This Service Letter reidentified as
Service Bulletin M 20-92
per Service Instruction M20-15.

SUBJECT: Insulation of Master Switch, Revision to Carburetor Heat Tube,
and Replacement of Vacuum Lights

MODEL AFFECTED: M20C, Serial Numbers as Noted Below

FIGURE 2

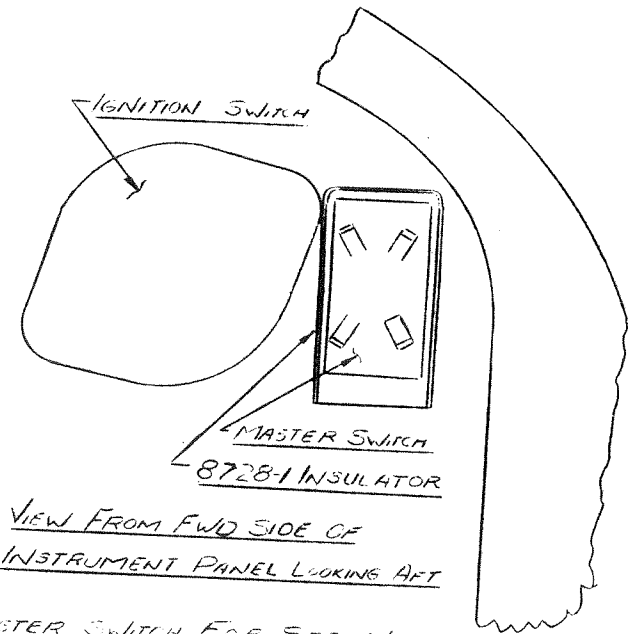
2. Revision to Carburetor Heat Tube — (for Serials 1852, 1940 through 1959). The carburetor heat tube, Part No. 6484-5, leading from the muffler to the carburetor air box has been redesigned to eliminate the possibility of burning a hole in this part through contact with the muffler. Part No. 6504-1 elbow has been added, effective Serial No. 1960 and on, for production. We recommend that this revision be incorporated on the twenty-one airplanes listed above.

Install Part No. 6504-1 elbow as shown in Figure 2. If the 6484-5 duct is burned through or severely scorched, it should be replaced.

Note:
 ROTATE 6504-1 ELBOW
 TO MAINTAIN MIN. 2.0
 CLEARANCE BETWEEN 6173 &
 6484-5 BEFORE
 DRILLING .135 DIA
 HOLE

FIGURE 1 - INSULATION OF MASTER SWITCH FOR SER NO
 1852, 1940, 1941, 1943, & 1945

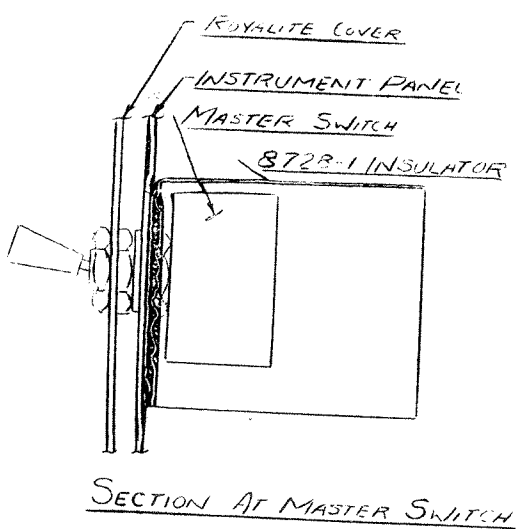
1. Insulation of Master Switch — (for Serials 1852, 1940, 1941, 1943, and 1945). The installation of the master switch, Part No. AN3027-2, has been revised to add Part No. 8728-1 insulator box, effective Serial No. 1946 and on, for production. We recommend that this revision be incorporated on the five airplanes listed above.

Install Part No. 8728-1 insulator box as shown in Figure 1.
